Asrotex

Dharmaganj, Enayetnagar, Fatullah, Narayanganj
(90.46031E, 23.62652N)
17 June 2014

Factory 1

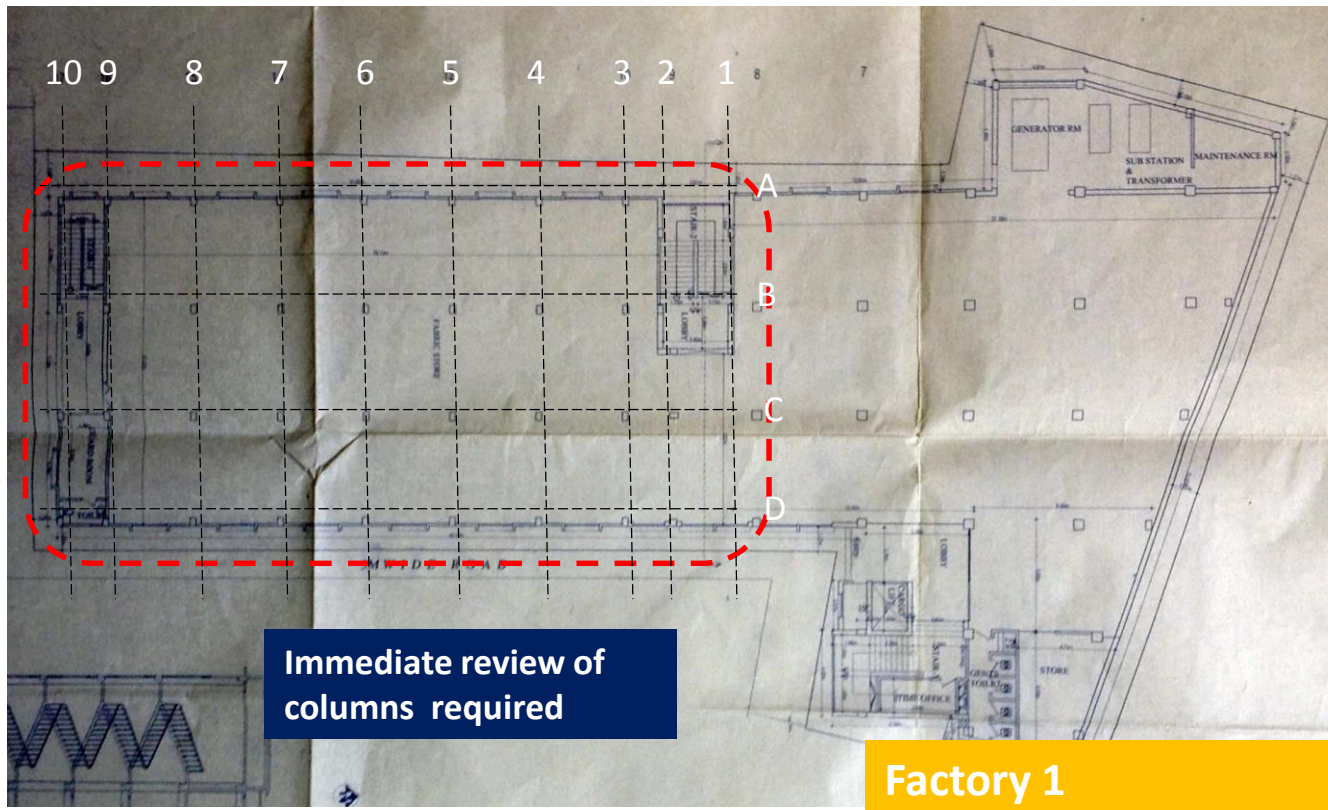
**Columns appear to be stressed to levels
that require immediate review**

Preliminary calculations suggest that columns are stressed to levels that require immediate review in Factory 1

Cantilever section of Factory 1 not indicated on permit drawings

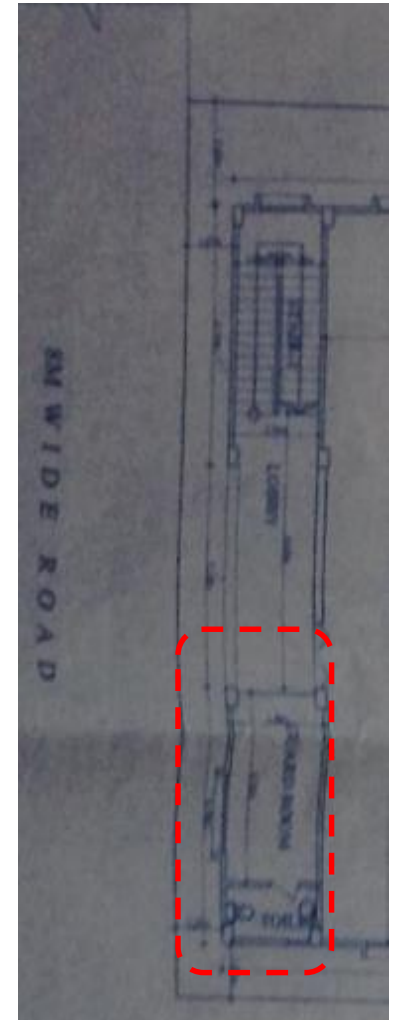
Columns C/10 and D/10 do not extend to ground and are supported on cantilever beams at first and second floors – this is not shown on the construction permit drawings

Flat slab to 5th floor of Factory 1

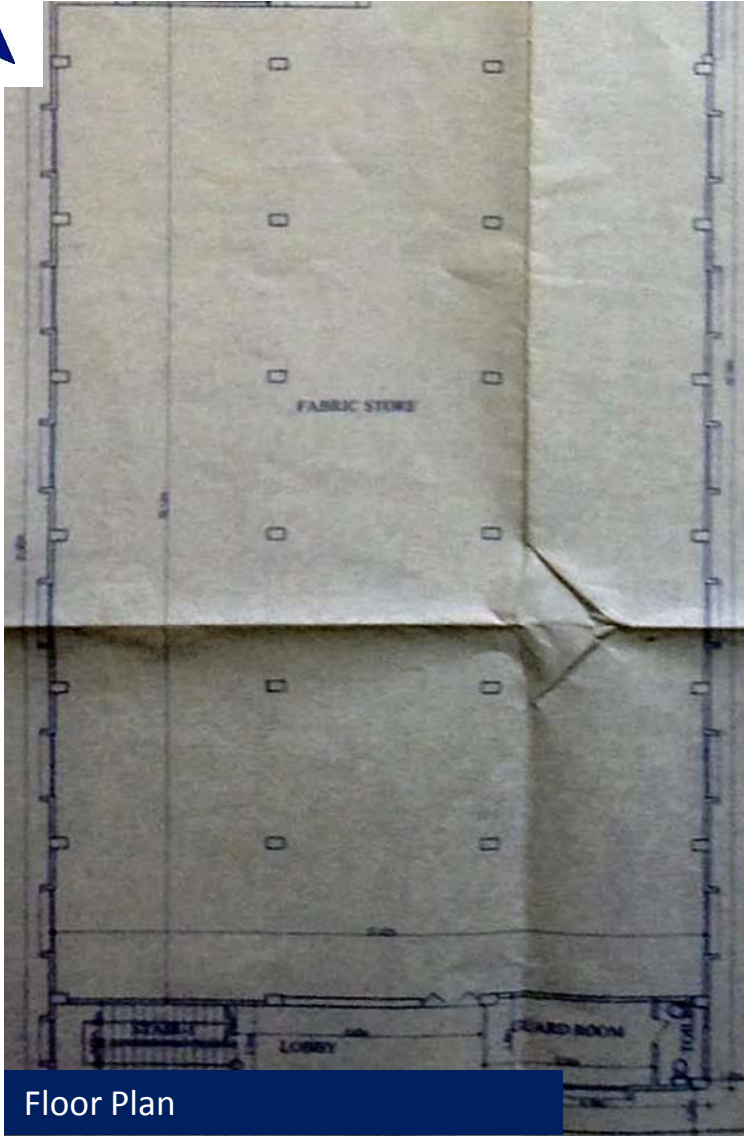
Moment frame stability system (column/beam) does not extend to top of building.

No punching shear reinforcement indicated on structural drawings provided

**Movement joint between Factory 1 and
Factory 2 buildings is stitched across**

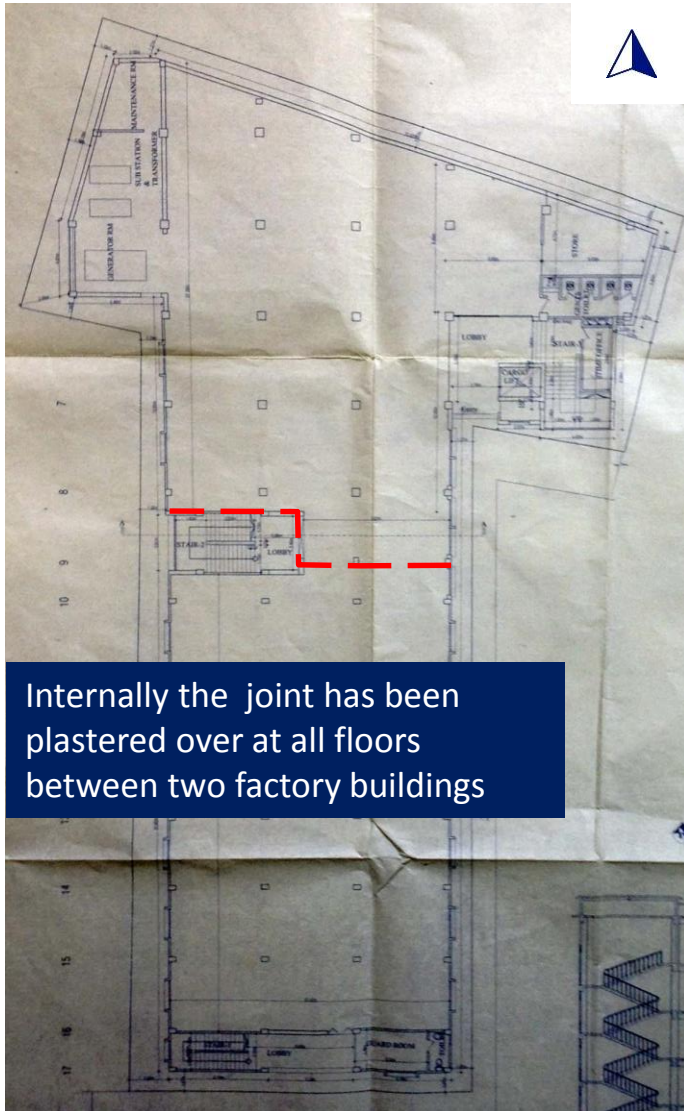
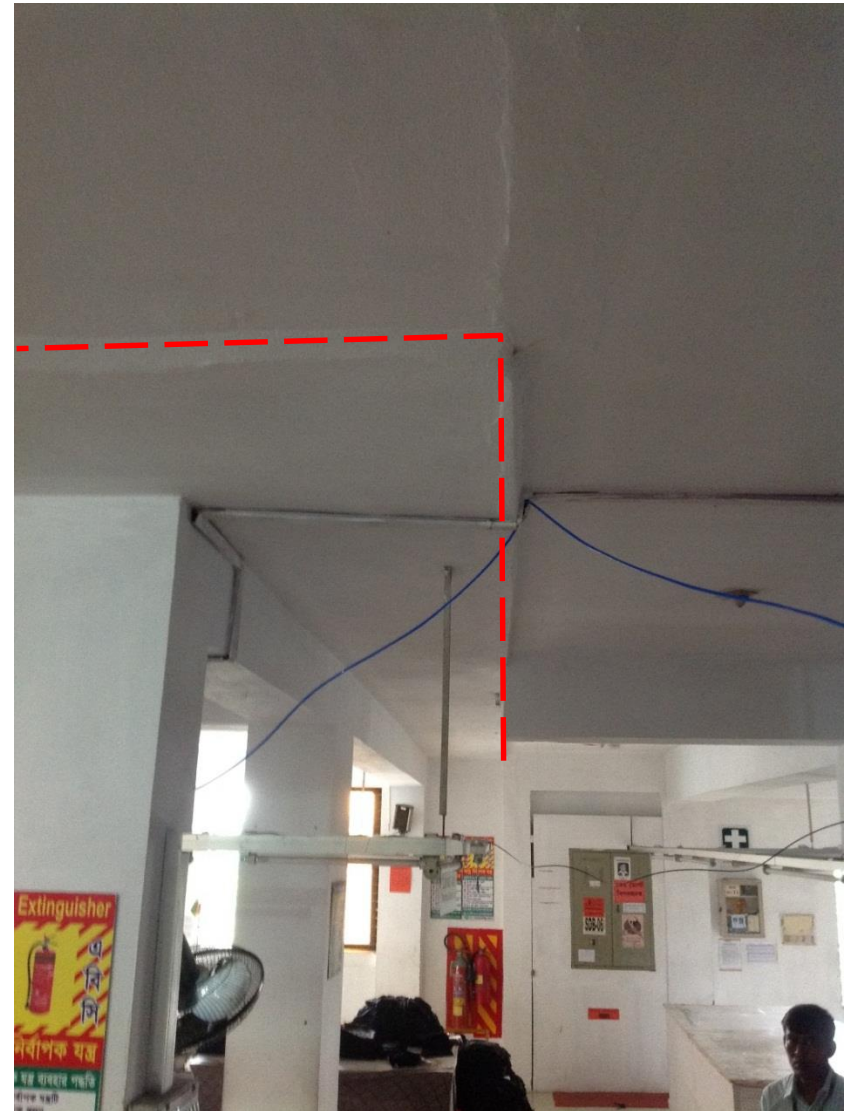
Factory 1 and 2 appear to have been built with no expansion joint. At 6th and 7th floors, Factory 2 is built across the connection line between the 2 buildings below

Internally the joint has been plastered over at all floors between two factory buildings

Office 2

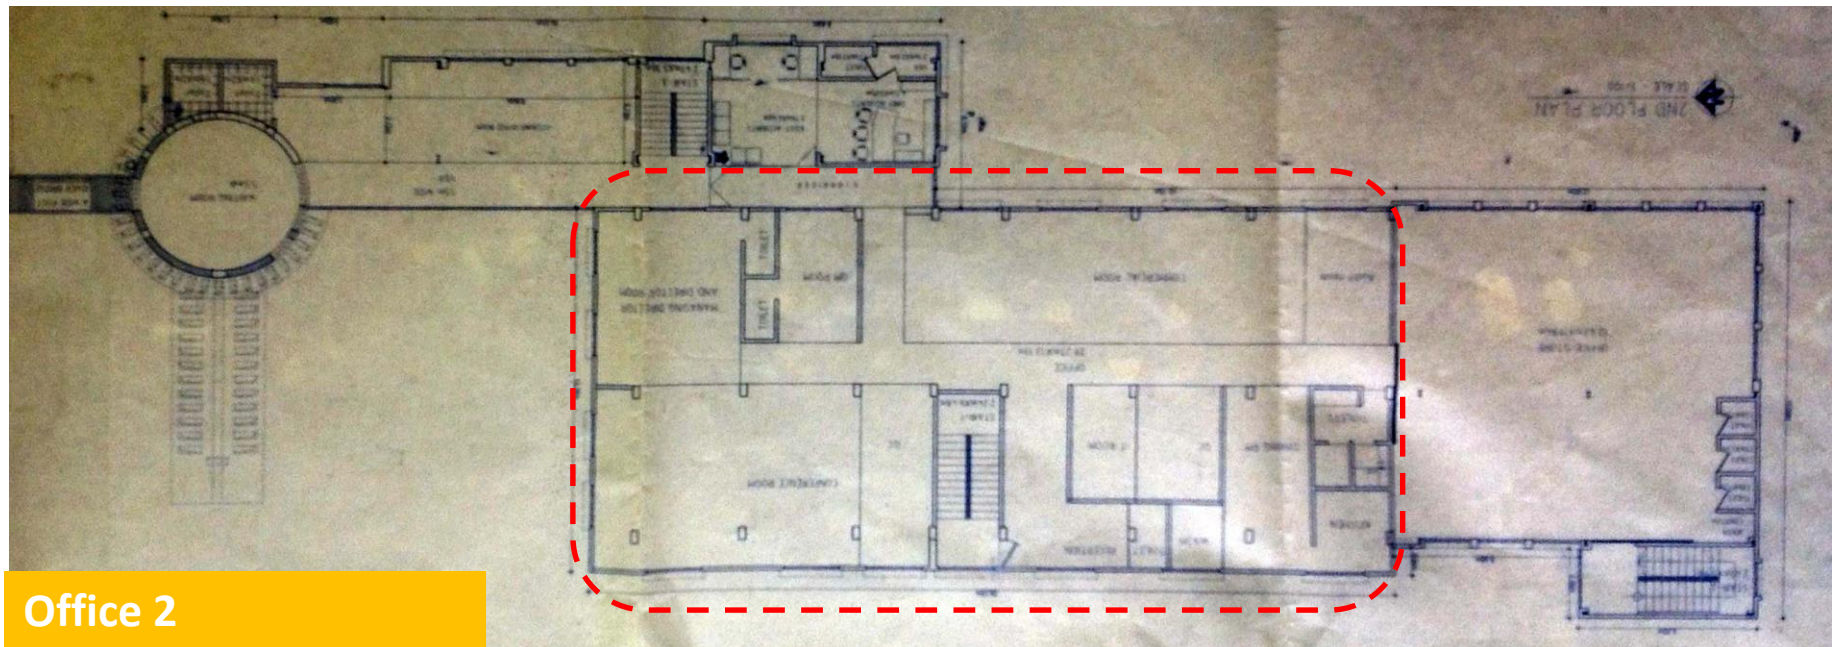
**Columns appear to be stressed to levels
that require review**

Preliminary calculations suggest that all columns are stressed to levels that require further review in Office 2

Uncontrolled Storage Loads in Office 2

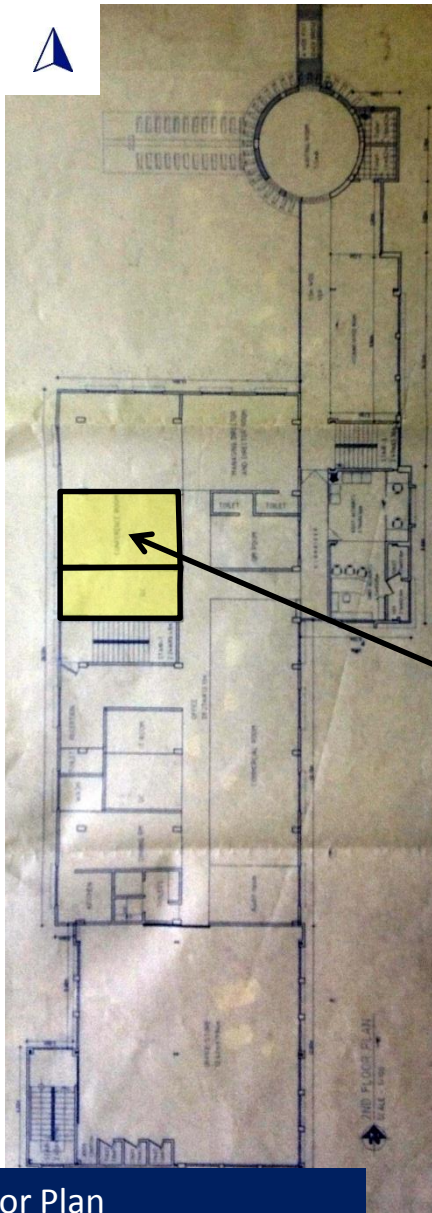
2m high bags of fabric off-cuts =
3.6kPa approx.

Deficiencies observed to steelwork connections in the Office buildings

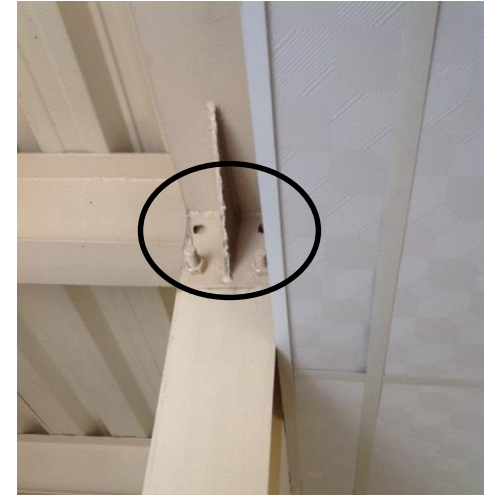
Beam web has been cut back before it reaches the supporting RC wall

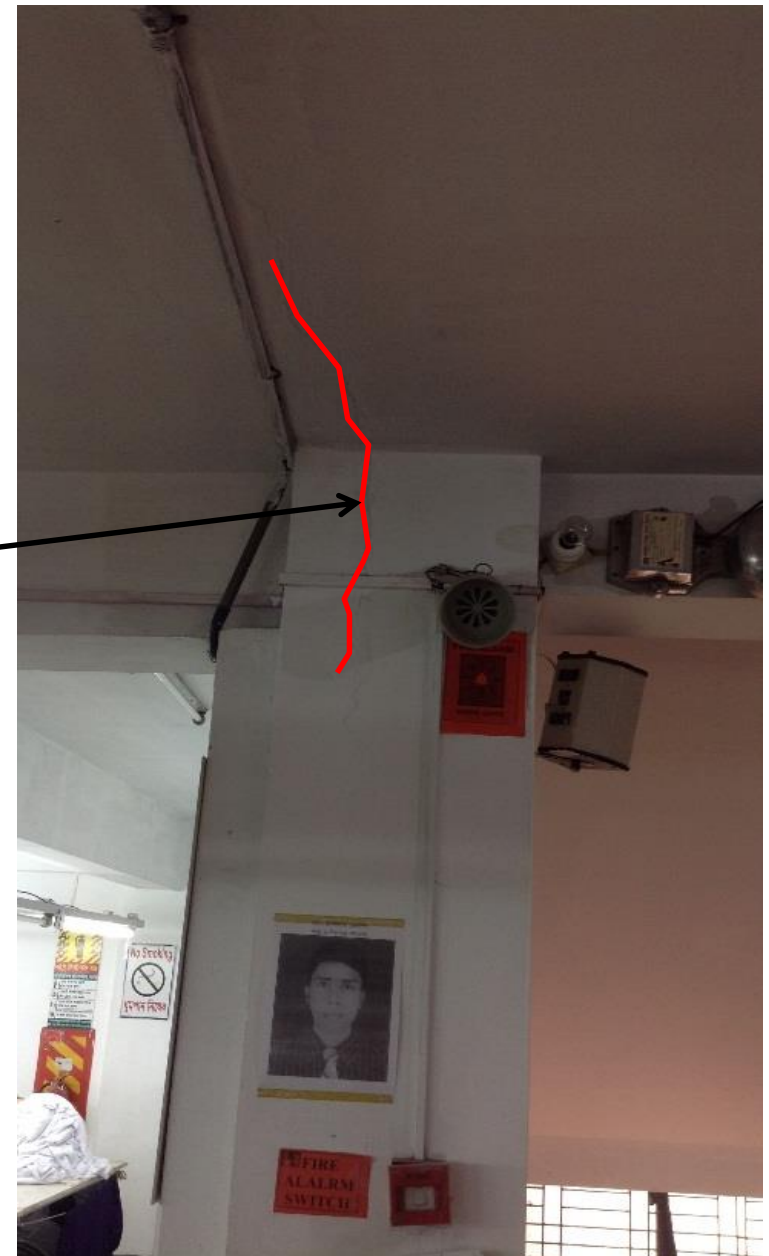
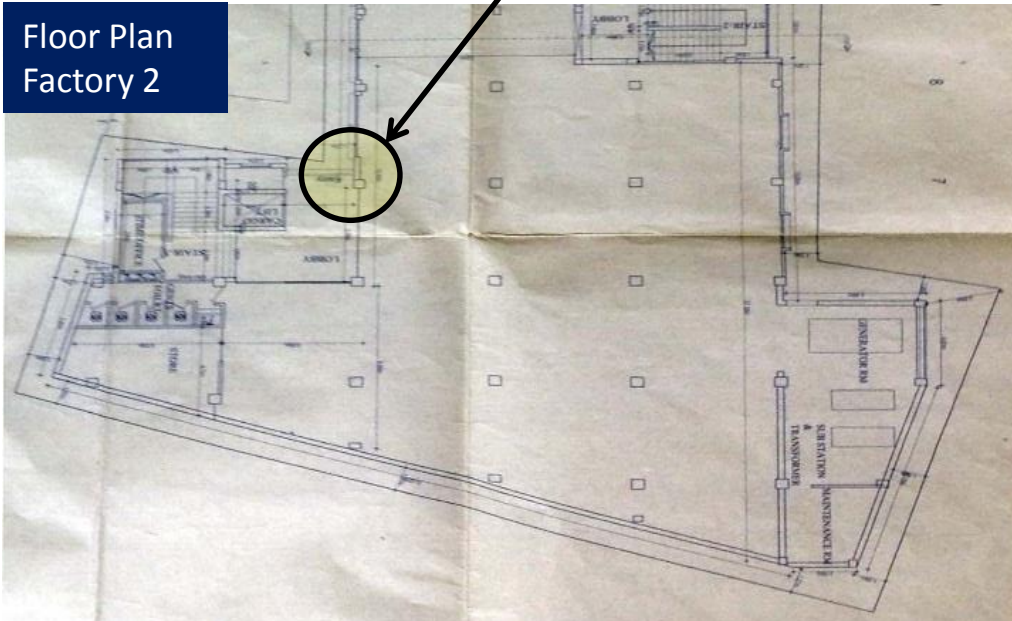
Steel-concrete connection detail unknown – reportedly the concrete was broken out locally and rebar exposed, with end plate welded direct to rebar

Missing bolts observed in Office 3

Steel deck roof to Office 2 appears inadequately tied down to the main structure

Floor Plan
Factory 2

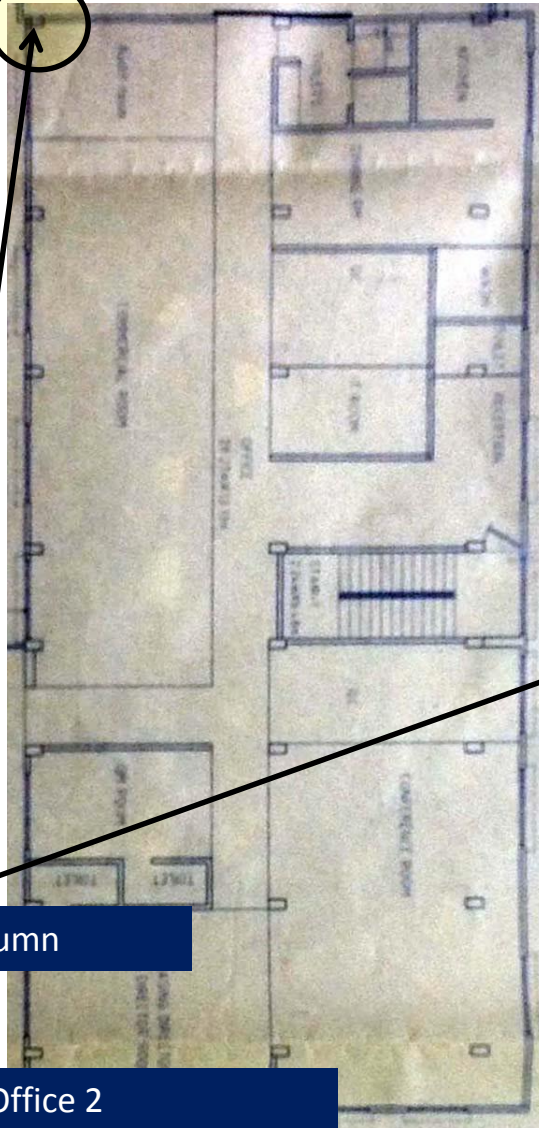
Crack in the column under the beam requires review

Floor Plan – Office 2

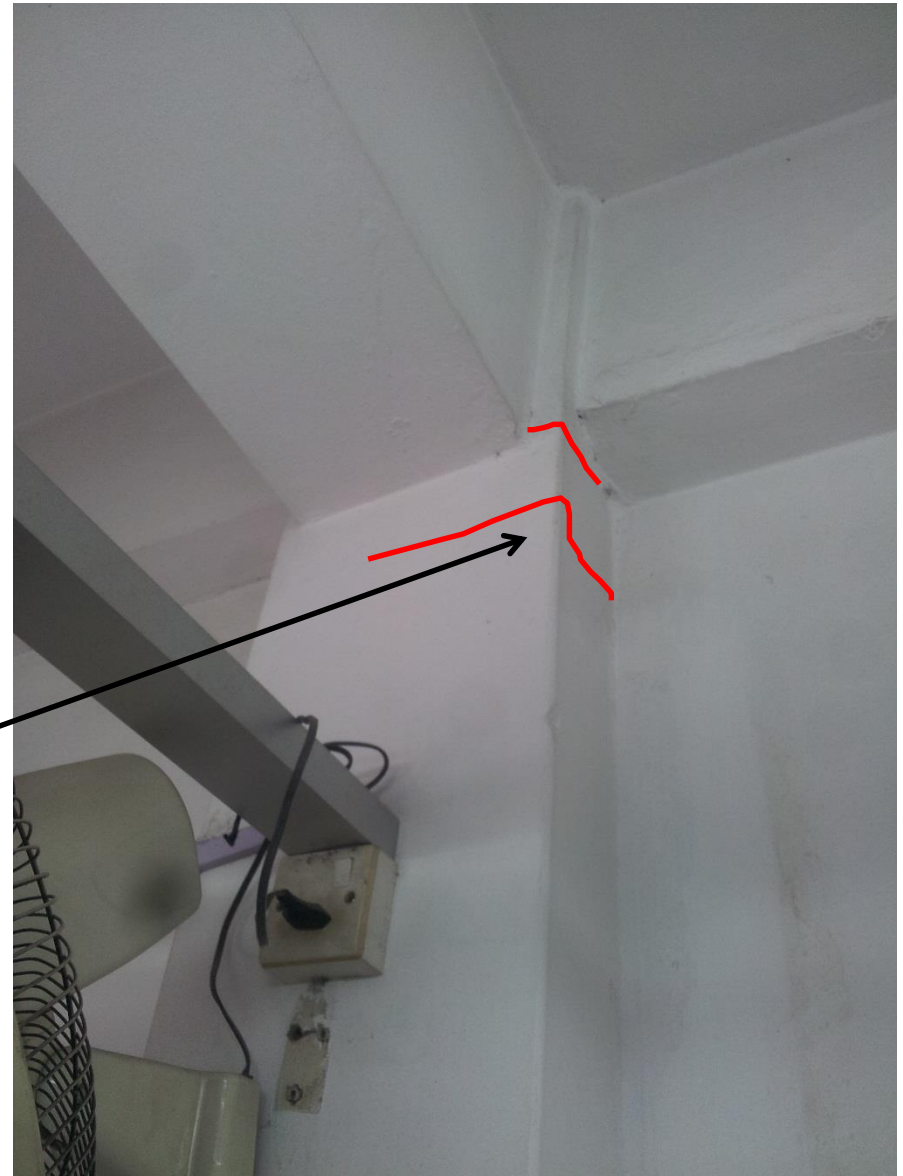
Crack in the corner column

Office 1

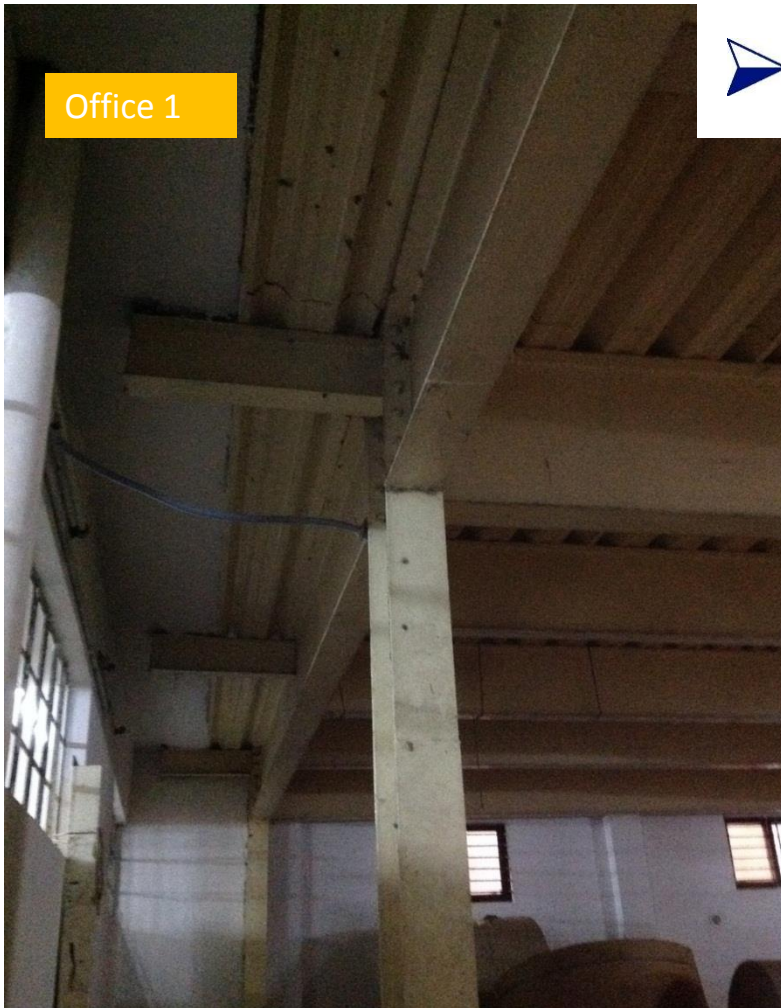
No vertical bracing was found in Office 1 steel structure. Composite decks assumed to act as diaphragms but connectivity to beams is unknown

Office 3

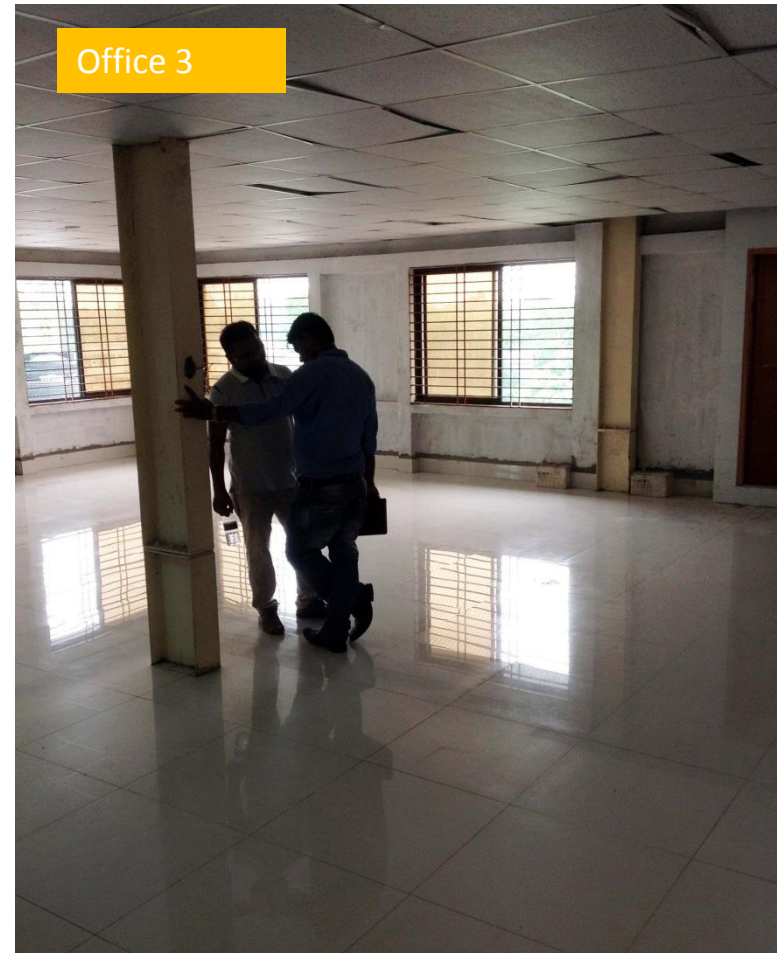
Simple connections and slender (minor axis) columns suggests the building is not a moment frame. Large window openings in perimeter walls
